**BEFORE THE HEARINGS PANEL  
FOR THE QUEENSTOWN LAKES PROPOSED DISTRICT PLAN**

**IN THE MATTER** of Hearing Stream 8 –  
Business Zones

**MEMORANDUM OF COUNSEL ON BEHALF OF THE QUEENSTOWN LAKES  
DISTRICT COUNCIL REGARDING UPDATED MODELLING FOR THE  
QUEENSTOWN TOWN CENTRE RECOMMENDED CHAPTER  
– HEIGHT PRECINCT P7**

**18 November 2016**

# Figure 11: Lower Shotover Street shading

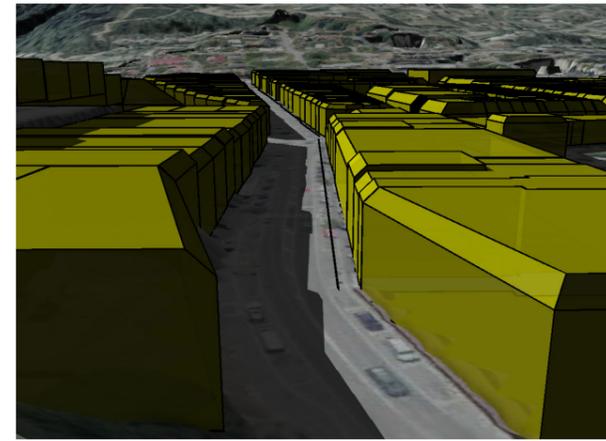
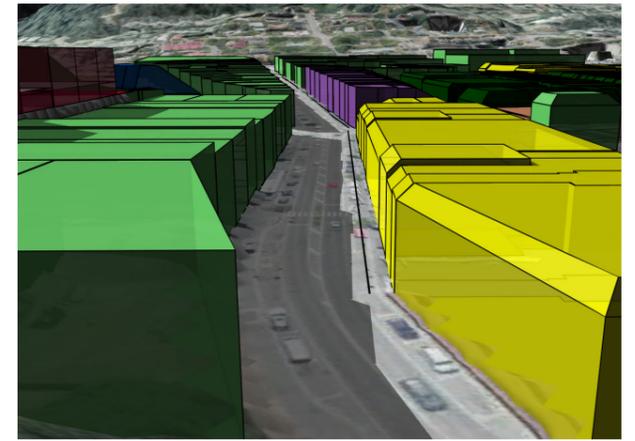
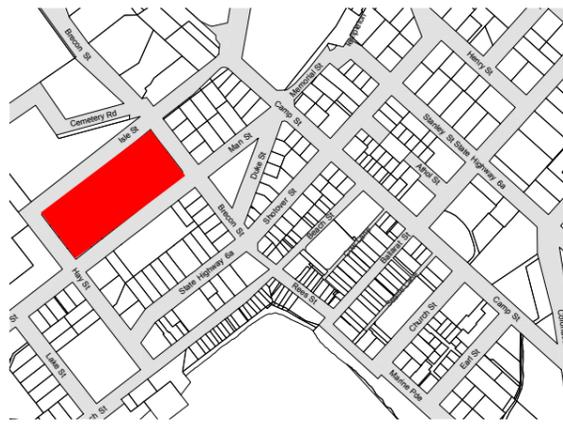
- (a) Amended Figure 2 in **Appendix 1**: this figure has been updated for consistency with the other amended figures;
- (b) Amended Figure 11 in **Appendix 1**: the annotation of the left-hand graphic is corrected to read "ODP" rather than "PDP" and the right-hand graphic is replaced with the amended recommended option, which is to not reinstate the recession plane rule, which exists in the ODP; and

Precinct 7.<sup>3</sup> Using the 11 August date<sup>4</sup> to provide a useful comparison between the shading created by the Operative District Plan (**ODP**) (which has been used in the methodology as a benchmark) and the redraft rules, it is apparent that removing the recession plane rule does not result in any greater shading of the opposite side of Shotover Street than results with the recession plane;

Figure 20: Man Street model

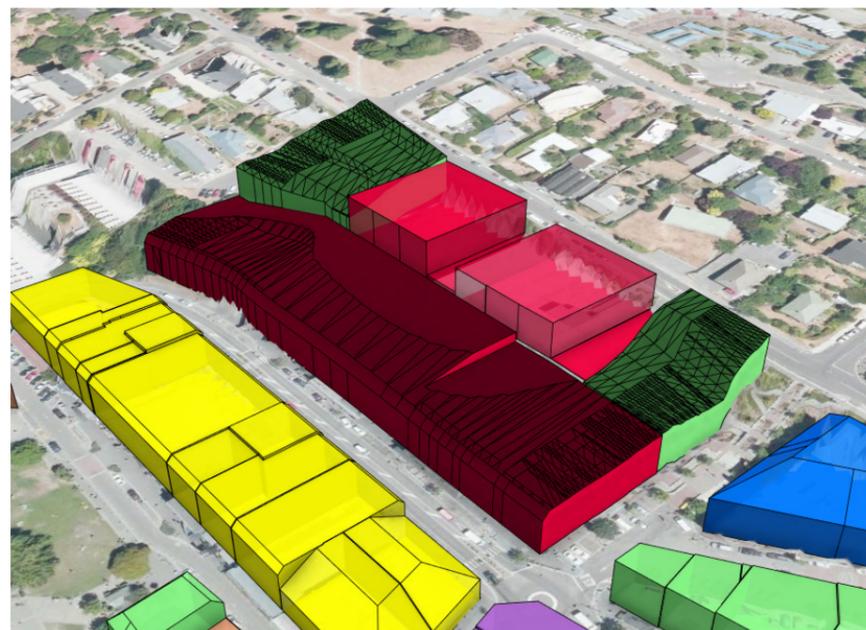
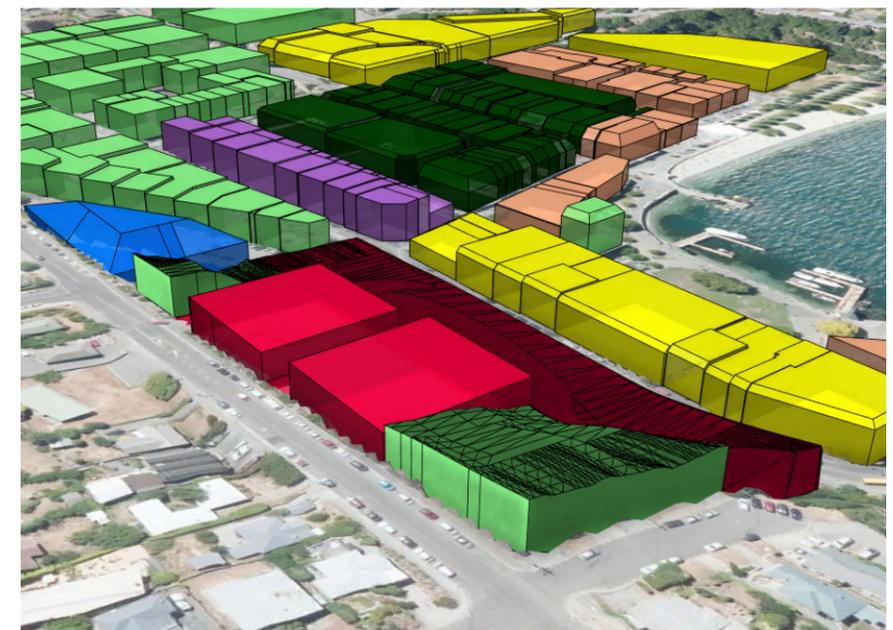
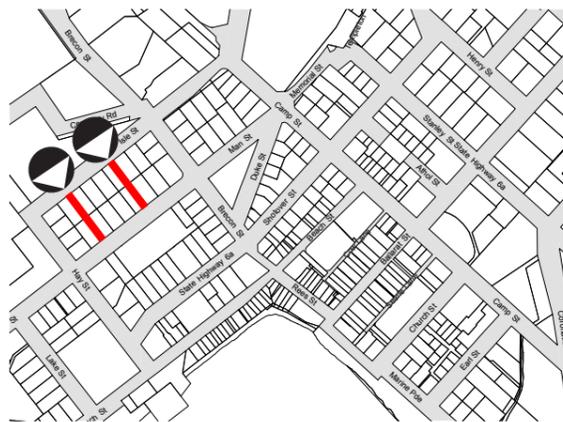
- (c) Amended Figure 20 in **Appendix 1**: Figure 20 of Mr Church's Appendix A did not accurately reflect the fact that redraft Rules 12.5.10.4(e) and 12.5.10.4(f) require the buildings to be no more than 12m above ground level, which in the case of areas E and F of Precinct 7 means that the 12m is a rolling height plane relative to the sloping ground level rather than a flat horizontal plane as was modelled. This has now been rectified in amended Figure 20. It is noted in the annotation to the amended Figure that it has not been updated to remove the recession plane due to time constraints and the desire to provide this information to parties without delay. Ms Jones and Mr Church have advised that they do not consider it important to understanding what the recommended rules seek to achieve, or the overall visual outcome that can be expected from the Rules, which is the primary purpose of Figure 20.

\* Recommended approach excludes the recession plane illustrated in the model view
